Comments on the Draft EIS and Responses

Southgate Project

Appendix I.3 - Southgate Project Response to Comments Side-by-Side Table

Figure I.5: Trends in Fossil Fuel Consumption by All Sectors (TBTU)

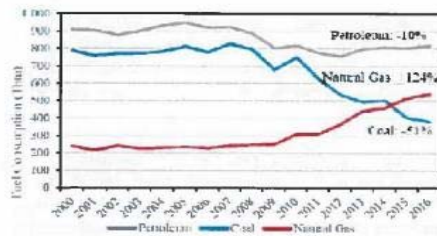
Alternatives: The EPA's earlier scoping comments recommended that FERC expand the evaluation of the alternatives. While we recommended to further evaluate the Duke Power Alternative (included in this DEIS), and to explore further 'co-location' alternatives that would reduce and minimize environmental impacts.

Recommendations: The EPA recommends expanding the System Alternatives section. The DEIS explanation of why this alternative is not feasible is

See response GEN-2 in appendix I.2.
